**MEMORANDUM****(RA-006-2015)**

**SUBJECT:** Henry County  
JL03 052 0146 002-010  
KY 146 Reconstruction Segment No. 1: KY 153 to Lost Creek  
Mileposts 2.1 to 6.8  
Item No. 5-8300.00  
Mars No. 8304401D  
Geotechnical Engineering Roadway Report Addendum

The purpose of this addendum is to update the geotechnical profile sheets to include the pipe sounding information so the rockline information at these locations will be available to the Contractor. The geotechnical notes sheet will be revised to include a note that discusses the pipe borings. A note will also be added concerning construction methods for shale within new embankments. These revised geotechnical notes and profile sheets should replace the previous versions. The CADD input for these sheets, in DGN format, is being provided to the Design Consultant, GRW Engineers, Inc., for inclusion in the roadway plans.

SOIL PROFILE, KY 146  
STA. 120+00 TO 150+00

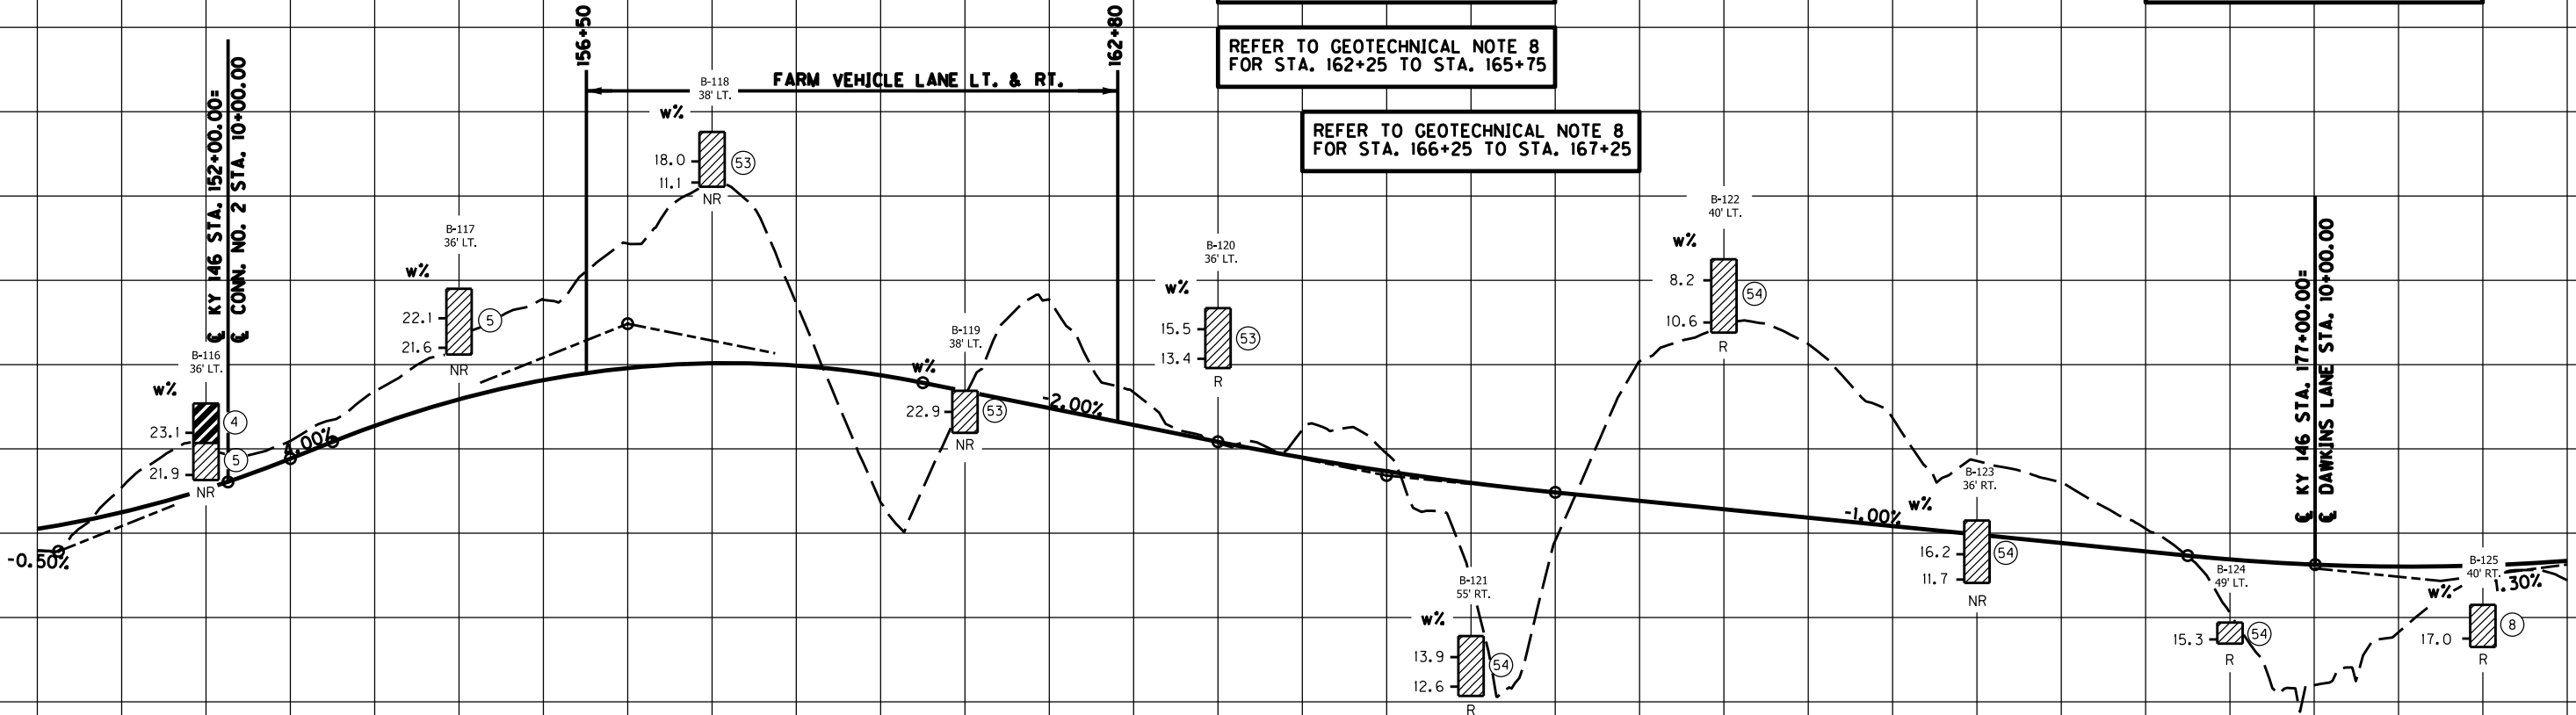
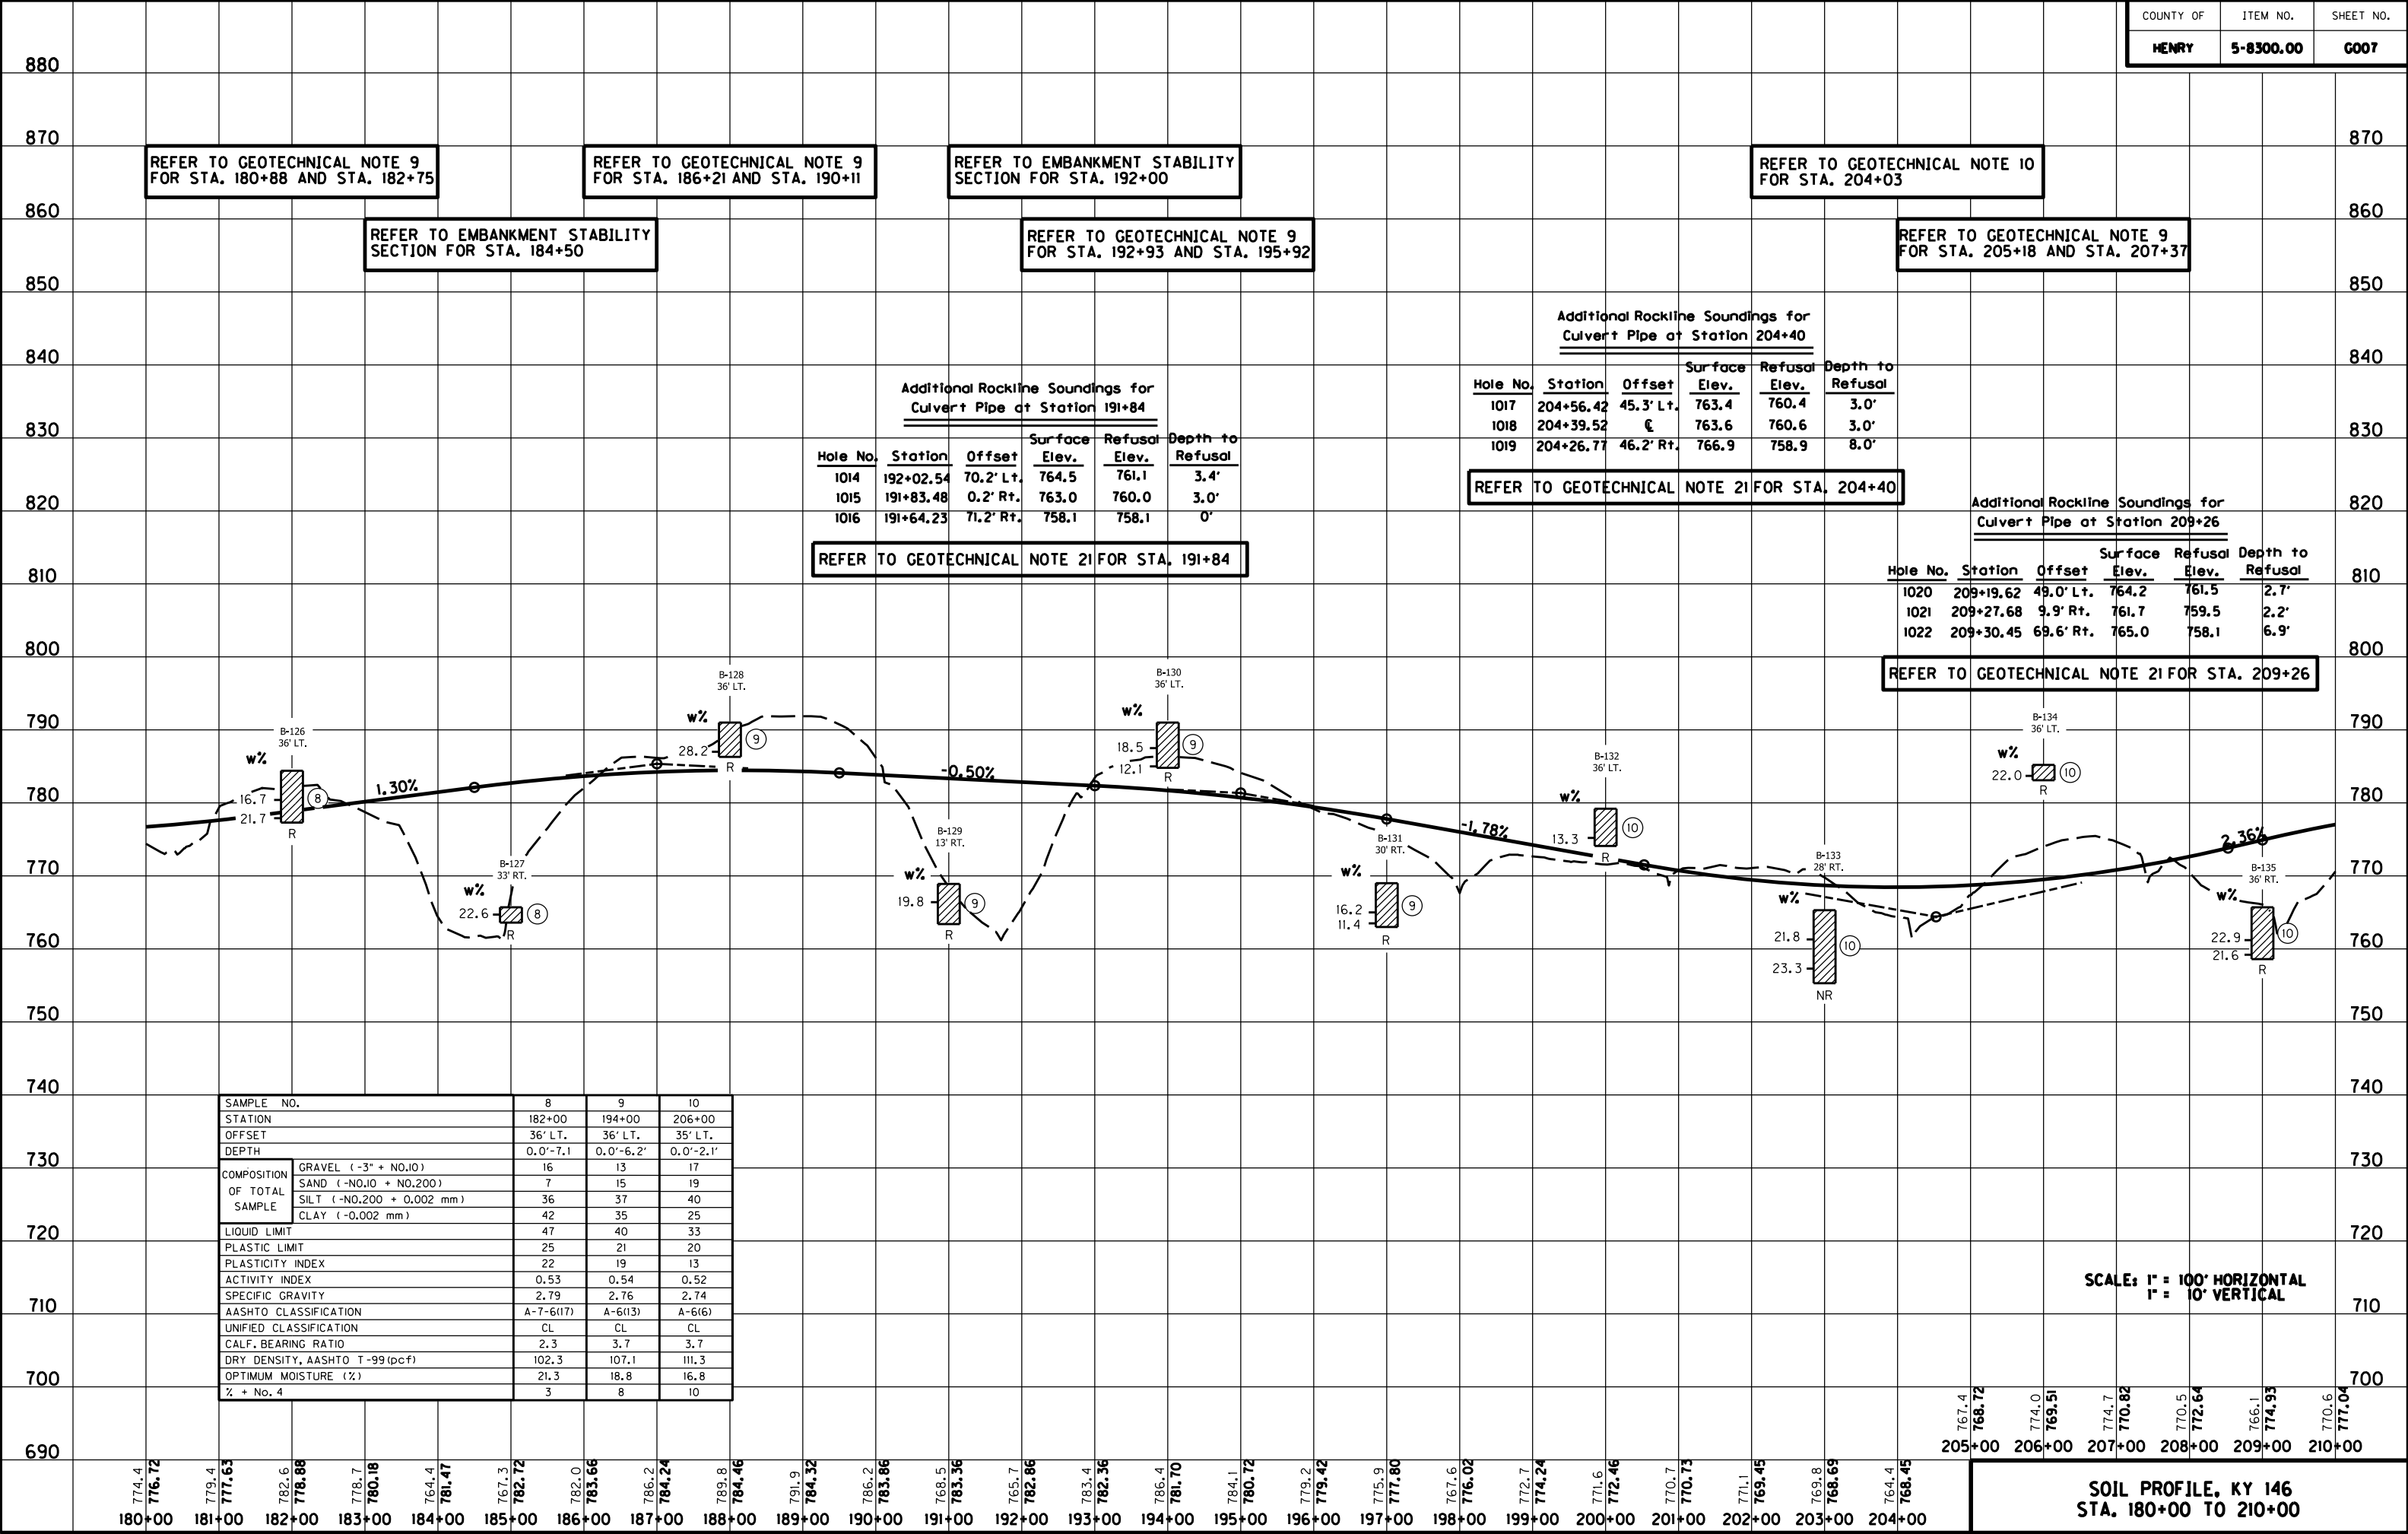
Additional Rockline Soundings for  
Culvert Pipe at Station 124+22

Hole No.	Station	Offset	Surface Elev.	Refusal Elev.	Depth to Refusal
1001	124+97.04	74.1' Lt.	758.0	754.2	3.8'
1002	124+59.69	36.2' Lt.	760.4	756.5	3.9
1003	124+19.77	2.2' Rt.	759.3	757.5	1.8'
1004	123+79.51	39.5' Rt.	763.4	759.2	4.2'
1005	123+37.03	79.9' Rt.	763.2	761.6	1.6'

REFER TO GEOTECHNICAL NOTE 21 FOR STA. 124+22
